# Product Change Notification

## Bourns® Model SRP4012 and SRP4020 Series Shielded Power Inductors Change to Core Channel Design

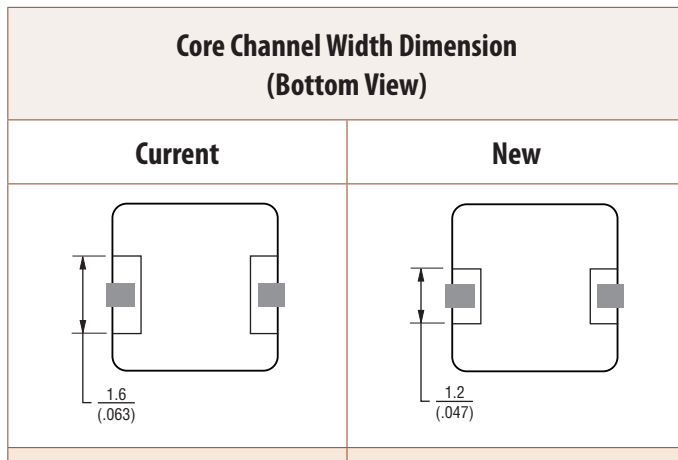
Bourns is changing the core channel design of the [Model SRP4012](#) and [SRP4020 Series](#) Shielded Power Inductors. The terminal positioning will change from 1.6 mm wide to 1.2 mm. Narrowing the core channel will better centrally align the terminal during manufacturing process.

The changes to the inductor core channel design will affect the inductor's form and its quality and reliability should be improved. The inductor's fit and function will remain unchanged. A list of the affected part numbers is shown in Table 1.
